**BOARD OF COUNTY COMMISSIONERS LAND USE
MEETING/PUBLIC HEARING**

MEETING DATE: April 22, 2025

DESCRIPTION: Fields Filing 1 Final Plat - Project File: SB2024-041.

Date: April 9, 2025
To: Douglas County Board of County Commissioners
Through: Douglas J. DeBord, County Manager
From: Terence T. Quinn, AICP, Director of Community Development *TQ*
CC: Heather Scott, AICP, Principal Planner
Jeanette Bare, AICP, Planning Manager
Steven E. Koster, AICP, Assistant Director of Planning Services
Subject: **Fields Filing 1 – Final Plat**
Project File: **SB2024-041**

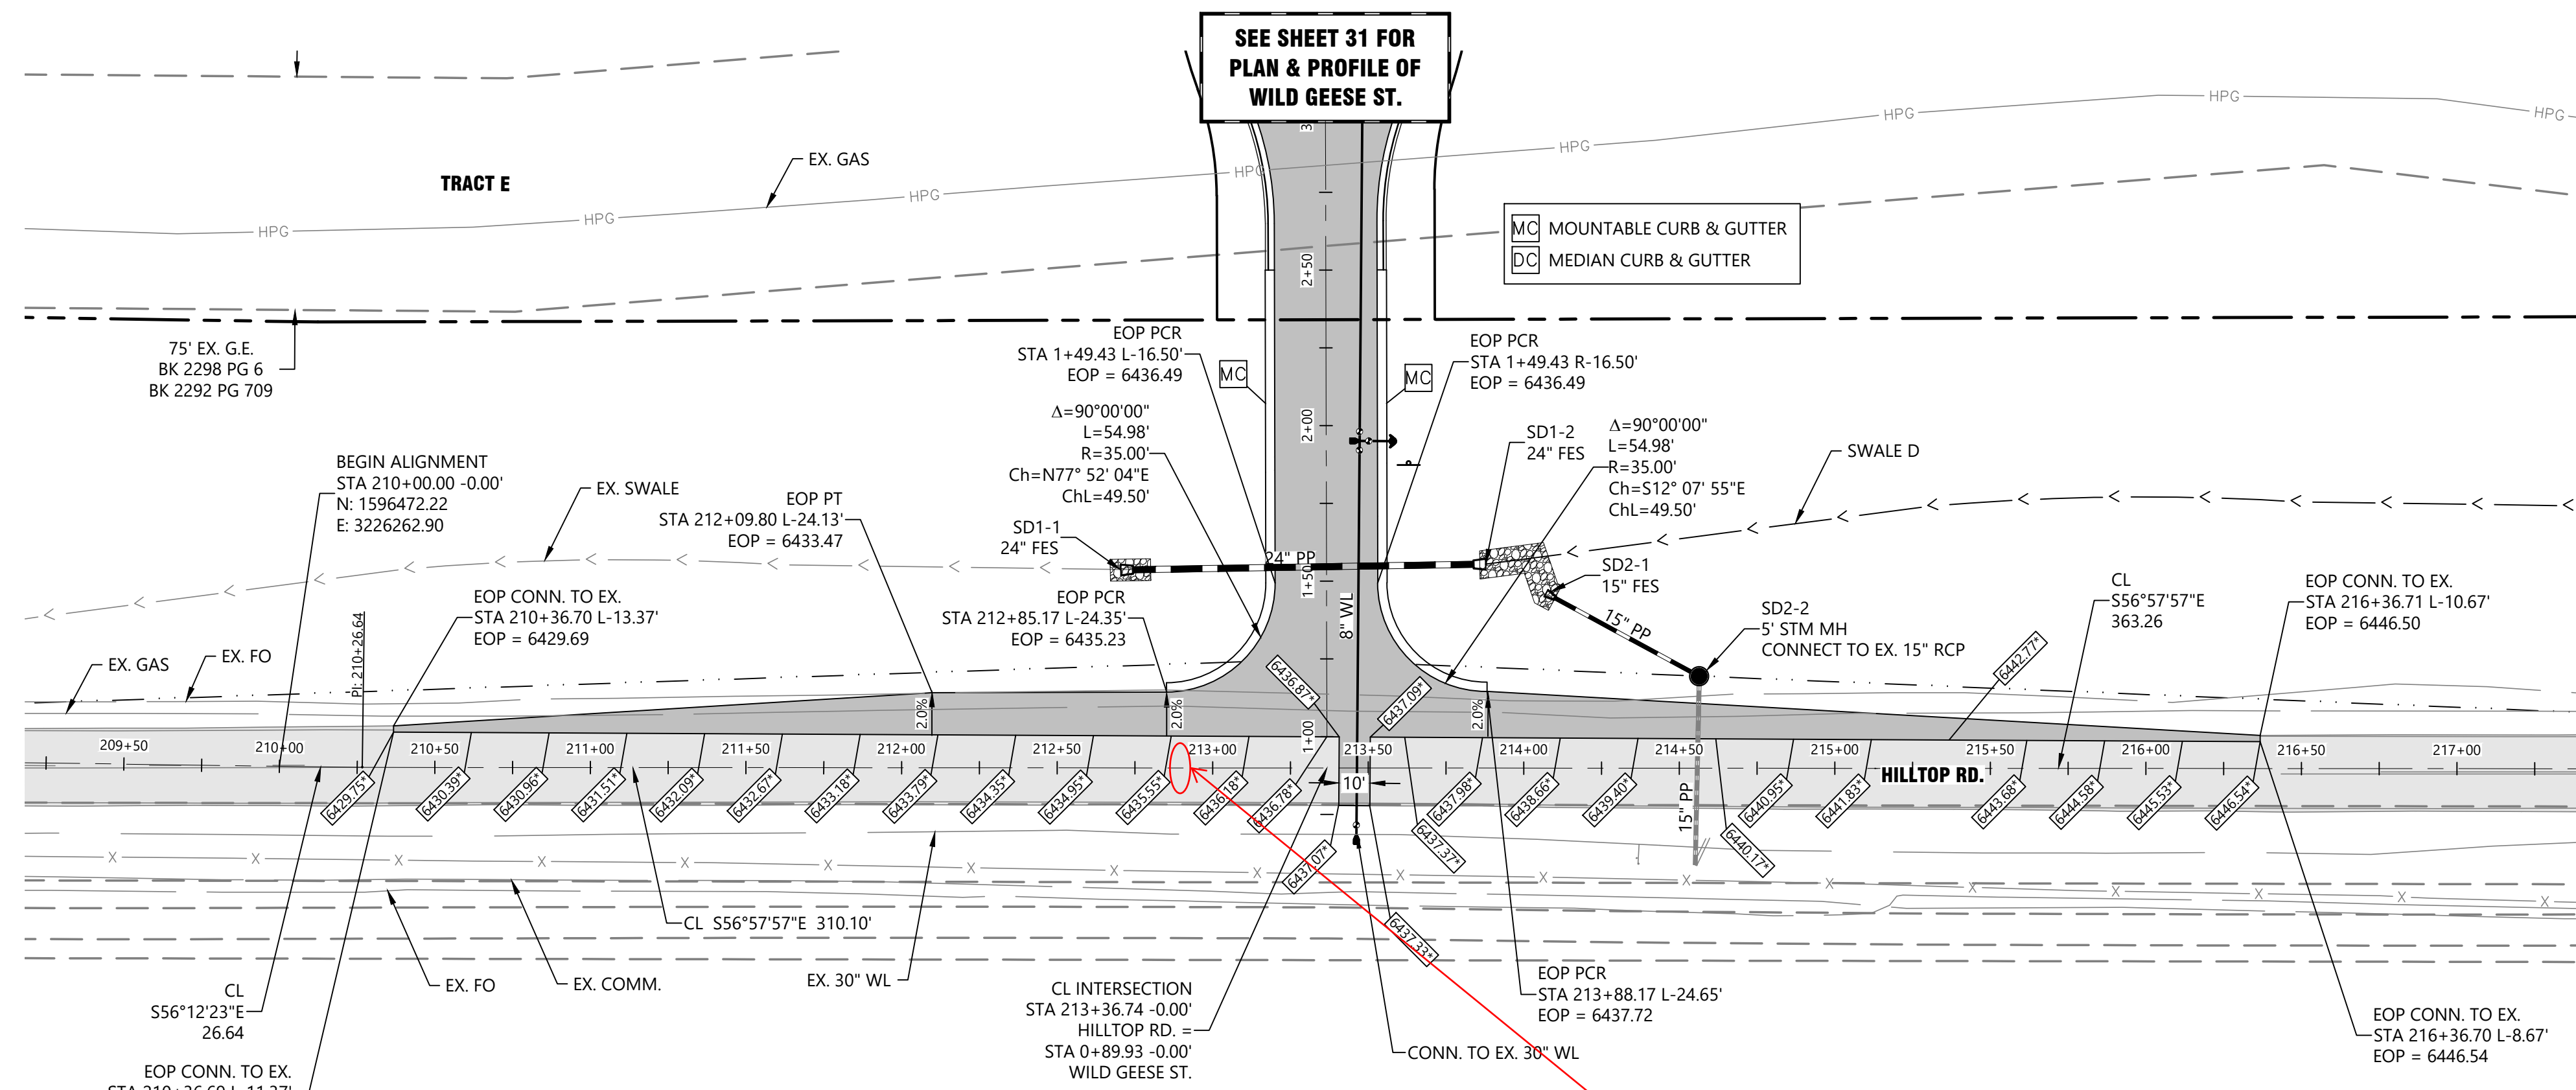
- Add OM3-L to the legend

For this interim phase, assume that the left turn decel lane will be centered in existing road section and widen both sides to allow for:
